The Commission has issued the enclosed Amendment No. 31 to Provisional Operating License No. DPR-20 for the Palisades Plant. The amendment consists of changes to the Technical Specifications and is in response to your request dated August 12, 1977, as supplemented September 26, 1977.

This amendment authorizes operation of the Palisades Plant at power levels up to 2530 megawatts thermal.

AMENDMENT TO PROVISIONAL OPERATING LICENSE

ATTACHMENT TO LICENSE AMENDMENT NO. 31  
PROVISIONAL OPERATING LICENSE NO. DPR-20  
DOCKET NO. 50-255

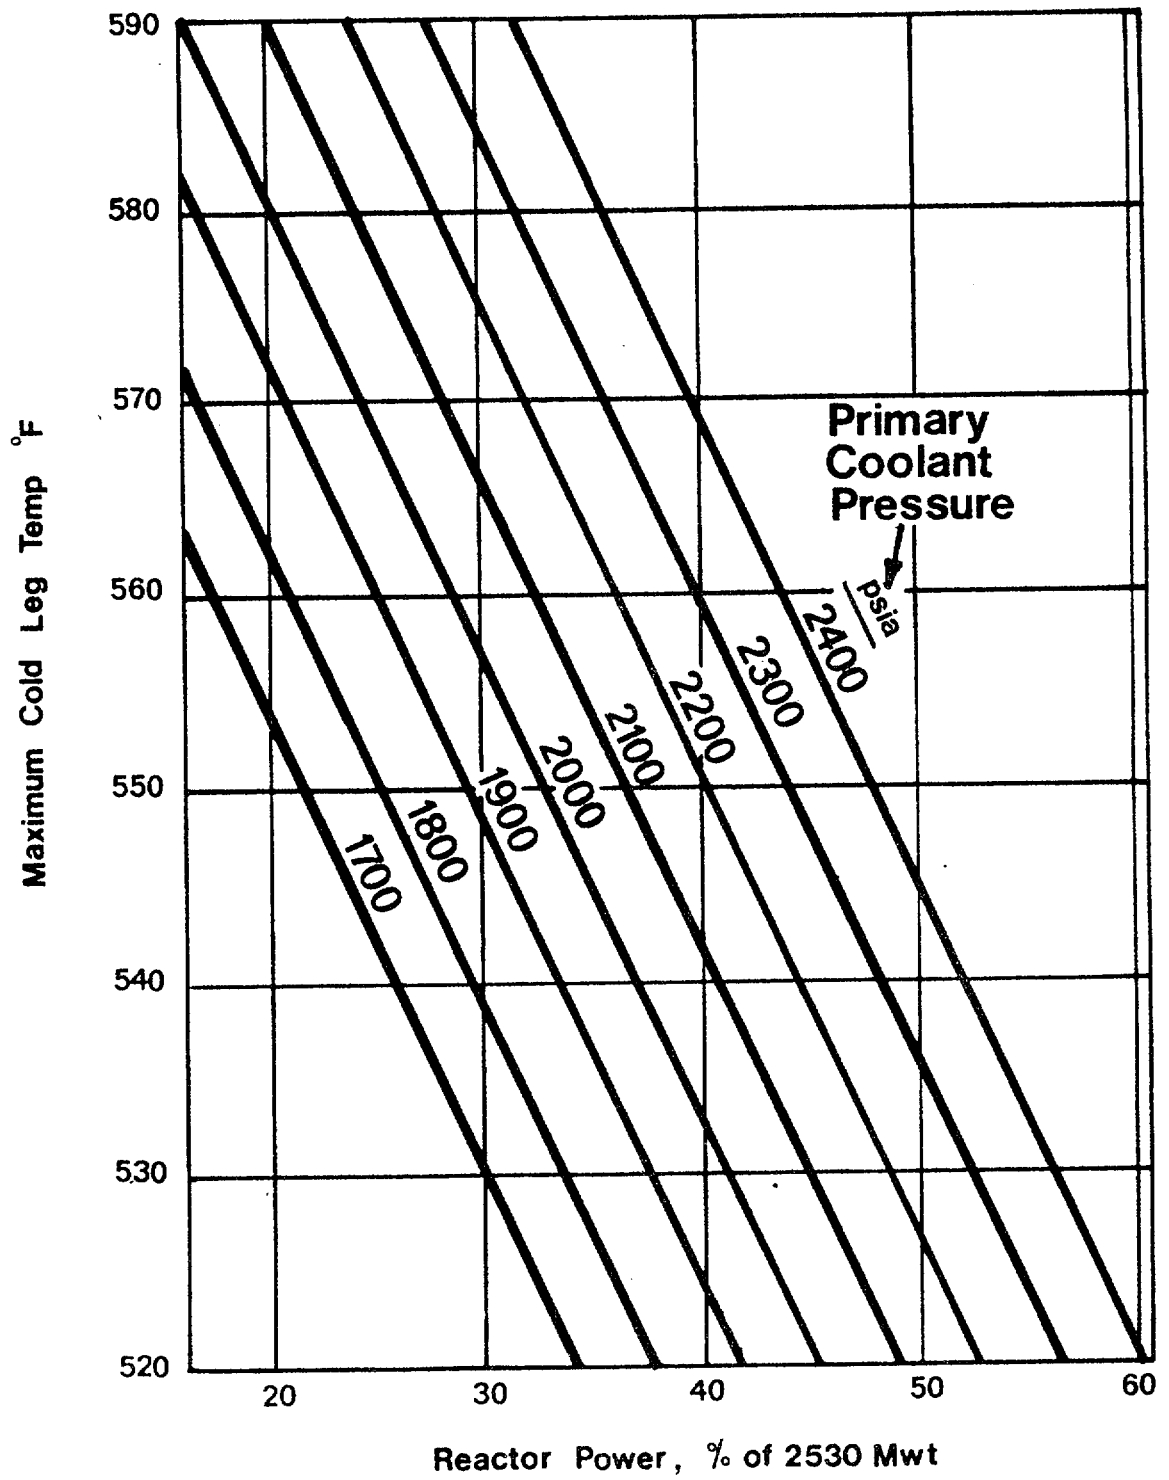
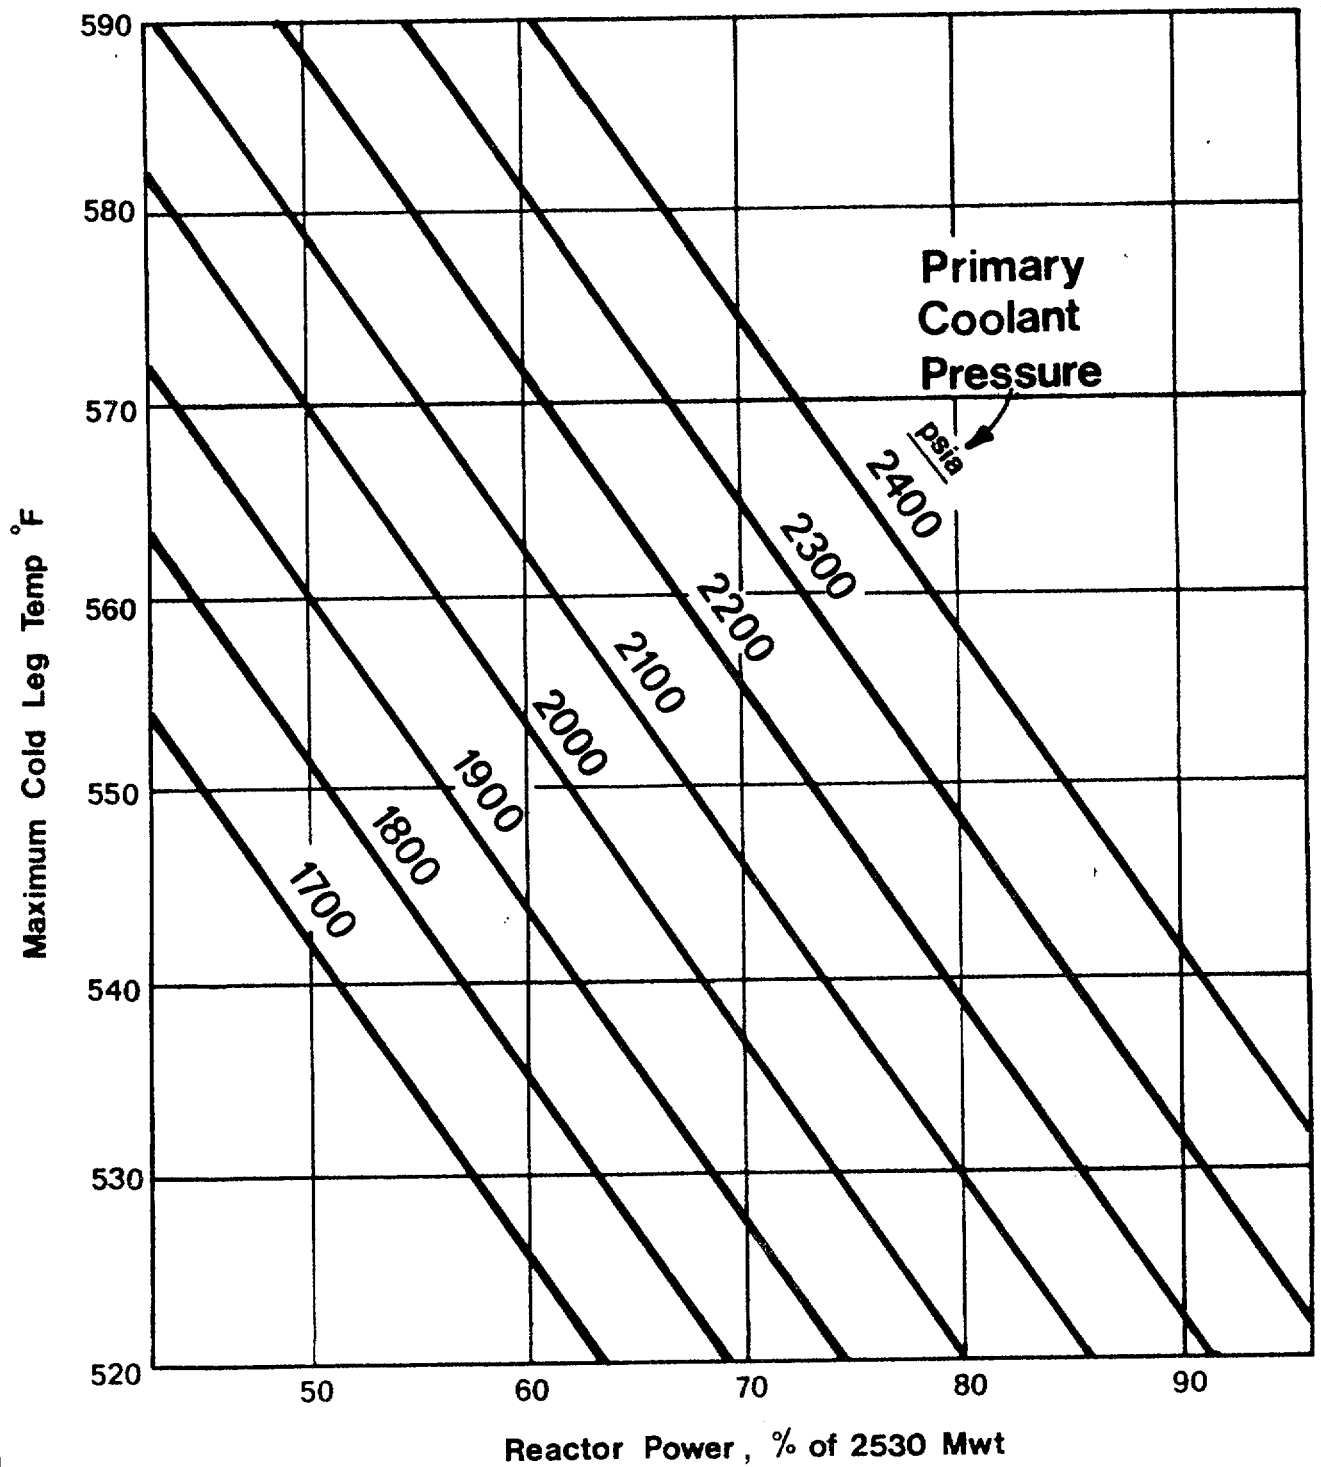
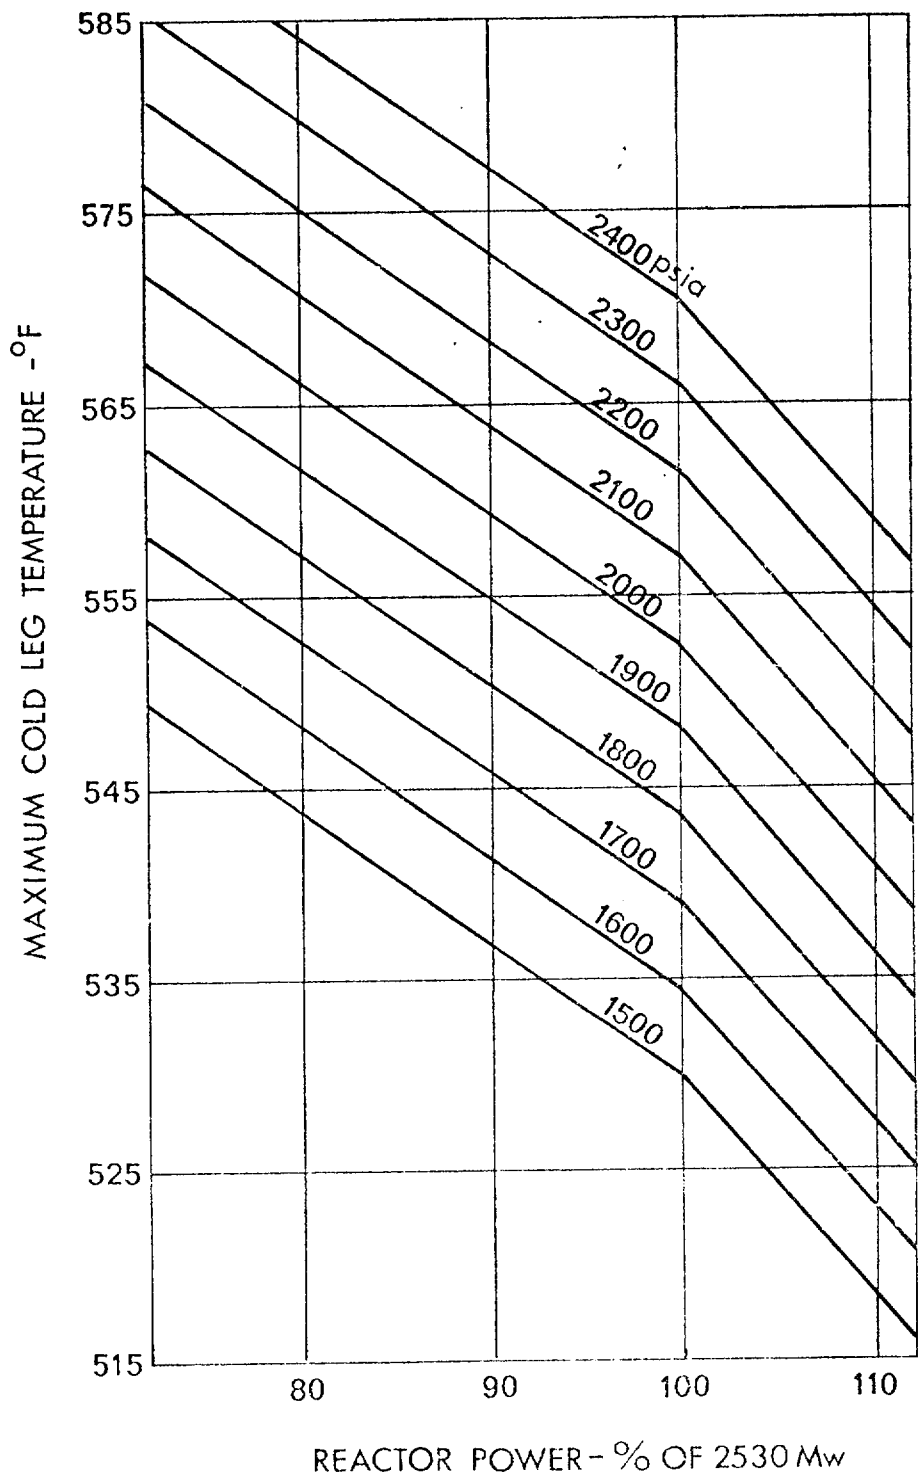
- Sec. 2.1 (Figs. 2-1,-2,-3) Reactor Core Safety Limits for 2, 3 and 4 Pump Operation have been modified for 2530 MWt operation.
- Sec. 3.1.1 (p3-1) The minimum 4 pump reactor vessel flow has been modified for 2530 MWt operation. Also a formula to adjust the thermal margin trip limits to accommodate flow reductions due to possible future steam generator tube plugging has been provided.

FIGURE 3-0  
REACTOR INLET TEMPERATURE  
VS  
OPERATING PRESSURE

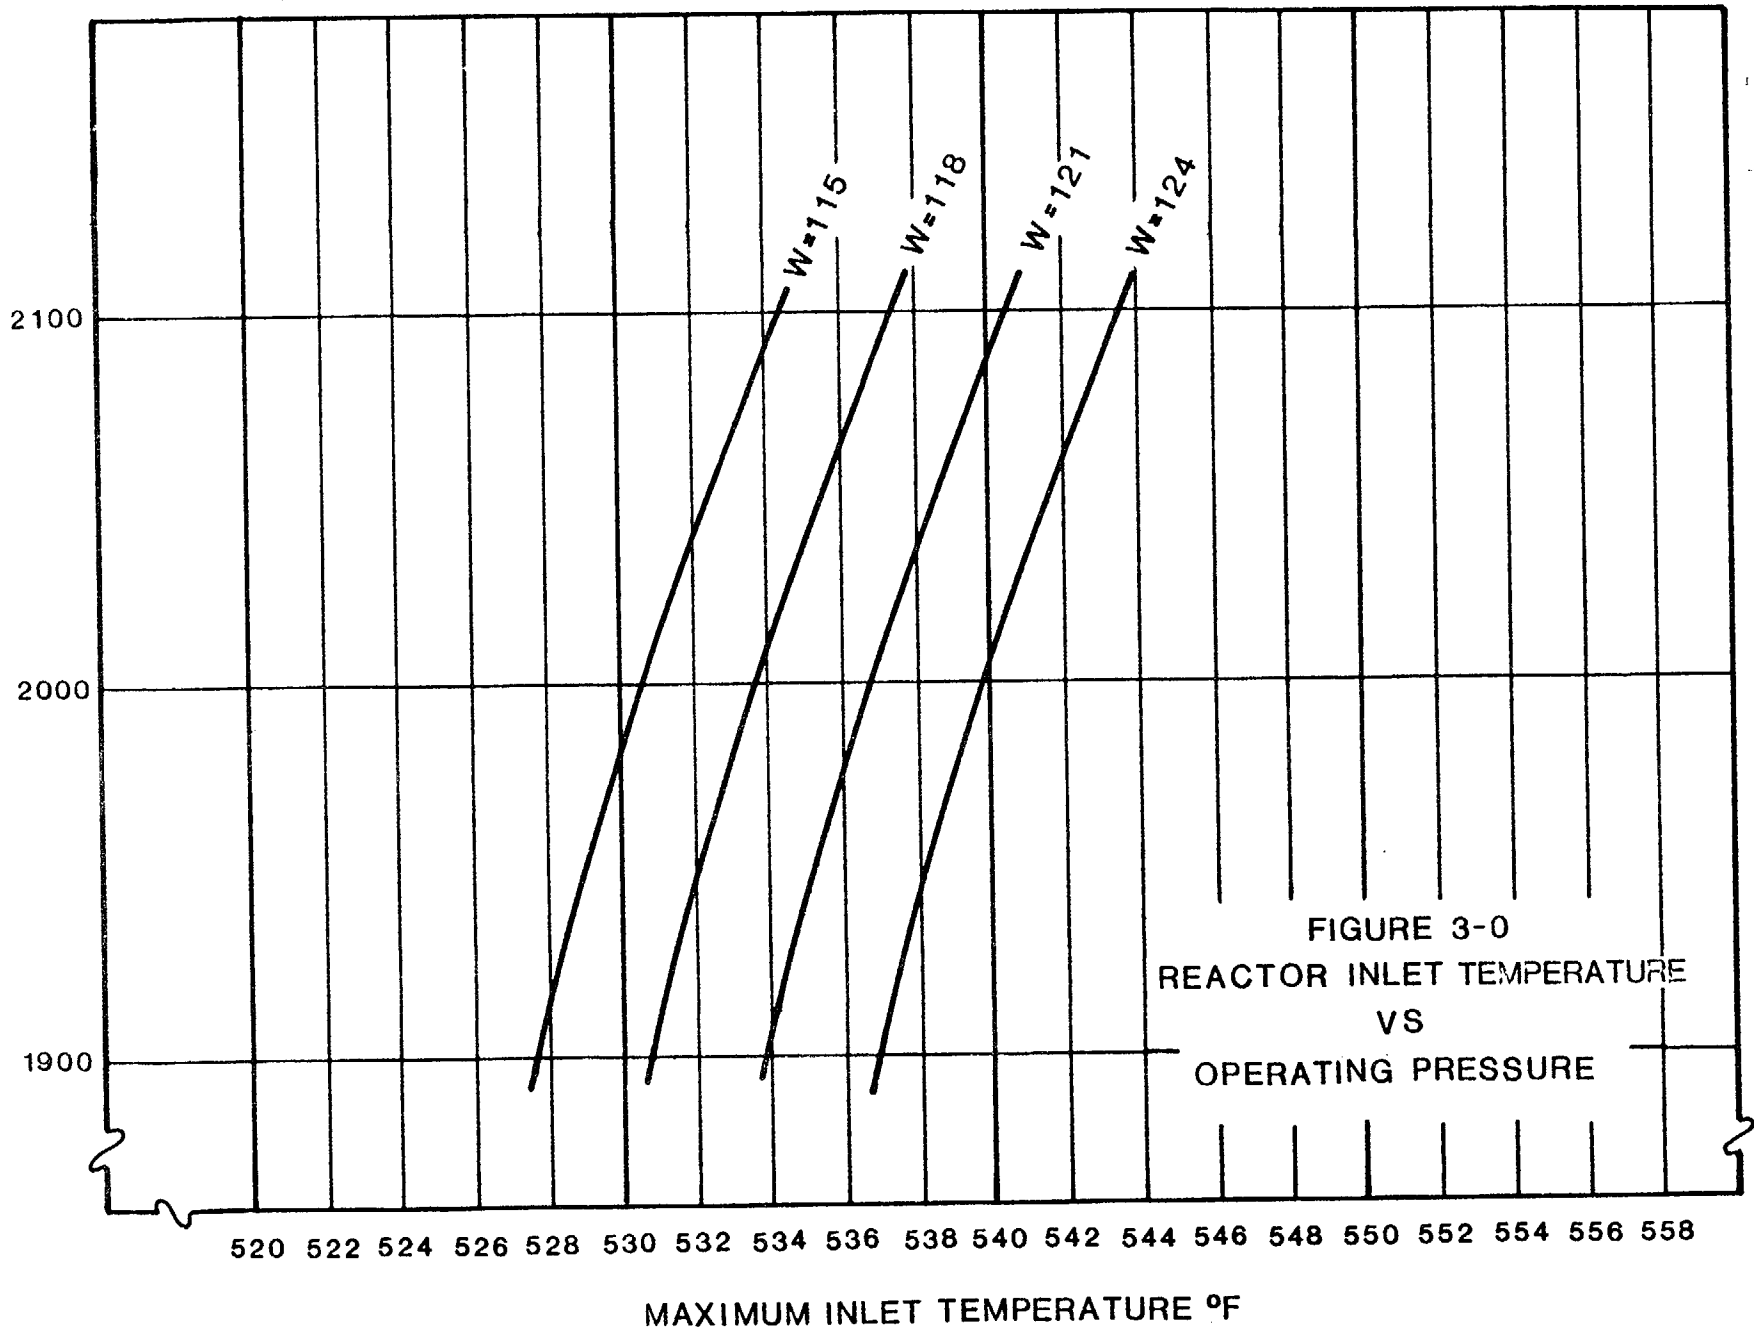
- Sec. 3.1.1 (p3-1a, Fig. 3-0) Reactor Inlet Pressure VS Operating Pressure for a given mass flow rate has been modified for 2530 MWt operation.
- Sec. 3.1.7 (p3-25) The minimum number of operable secondary system safety valves has been increased for 2530 MWt operation.

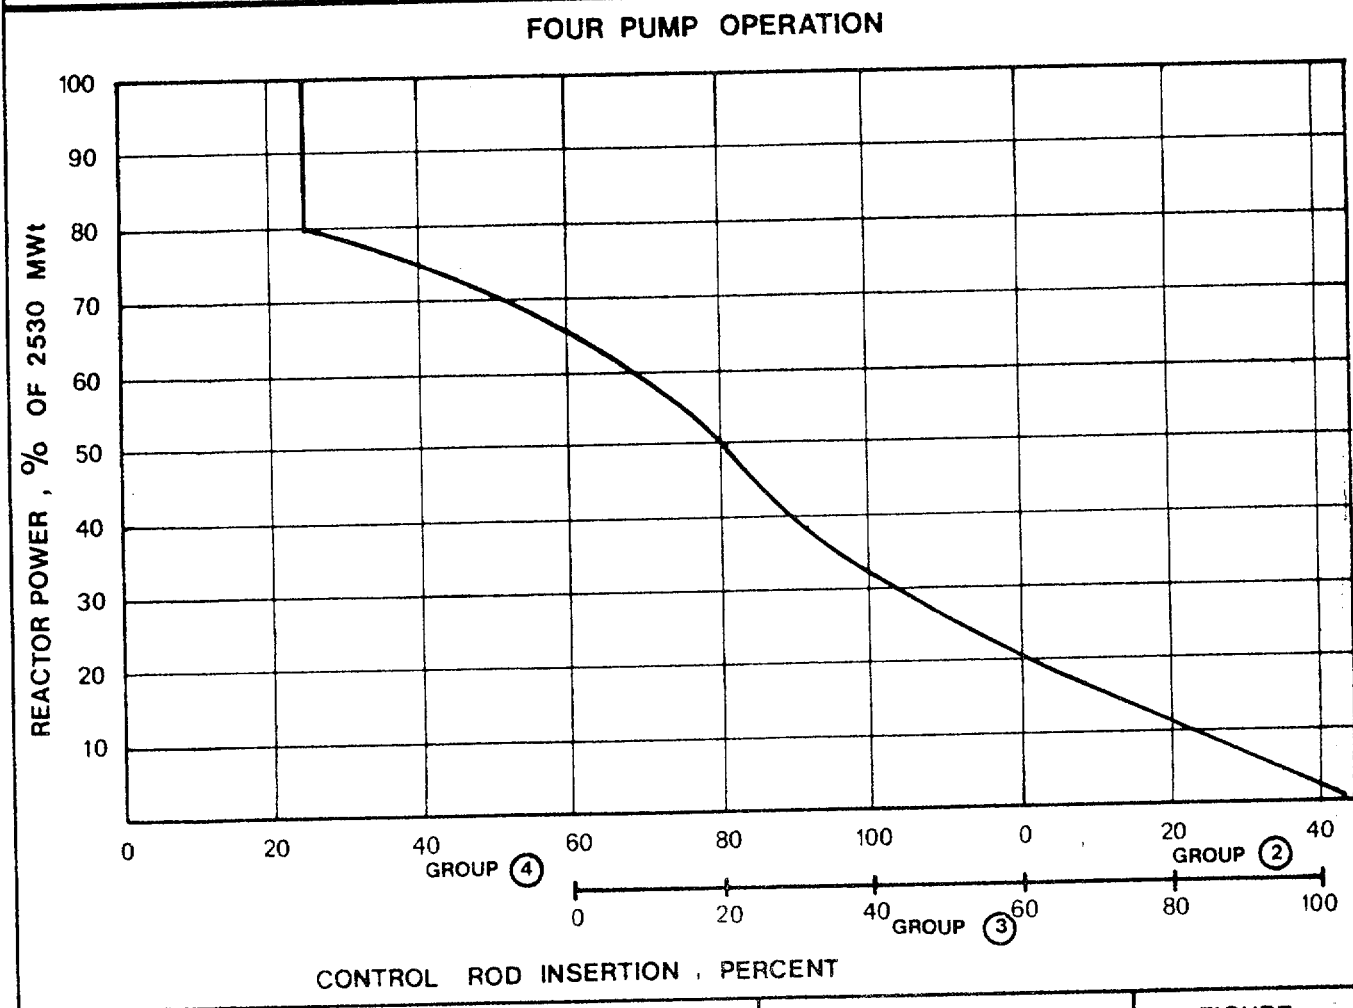
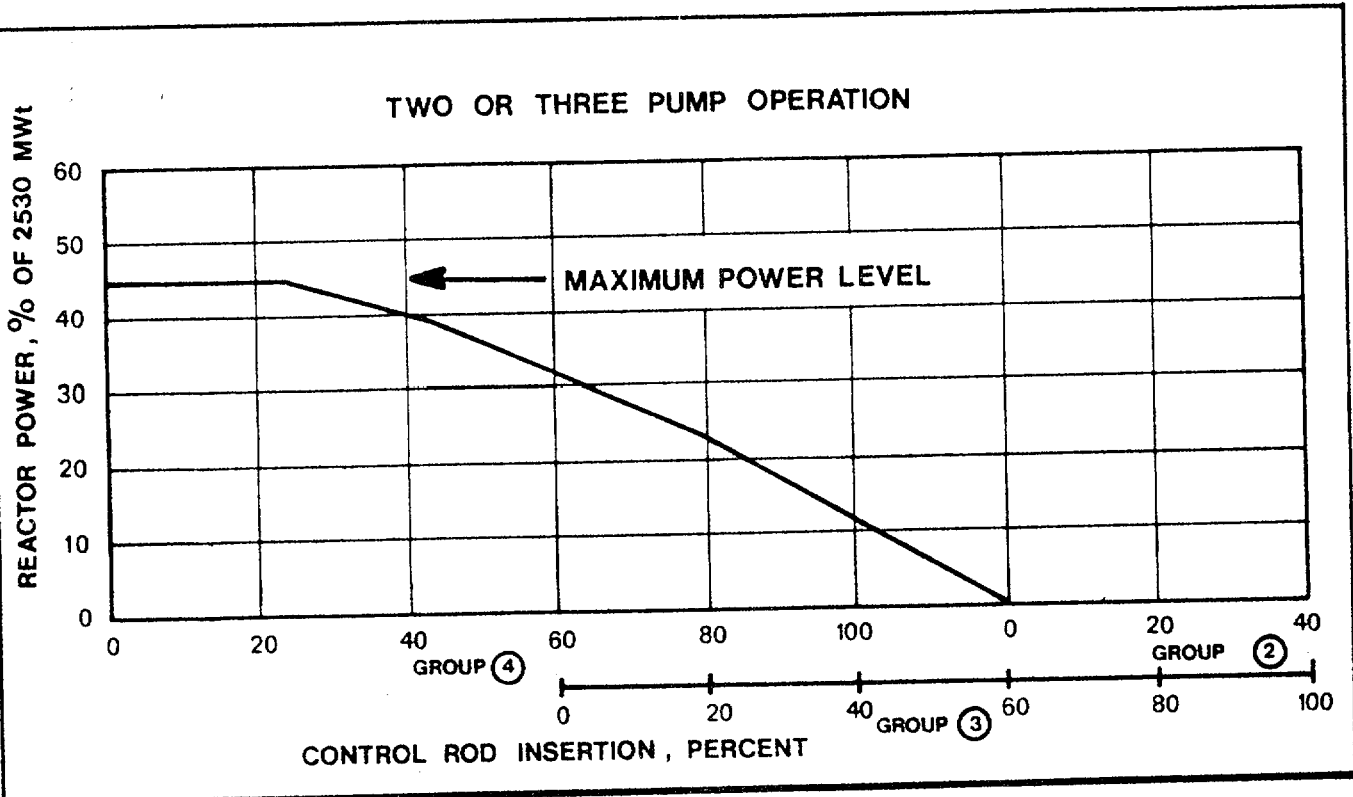
Sec. 3.10.5 (Fig 3-6) Control Rod Insertion Limits have been modified for 2530 Mwt operation.
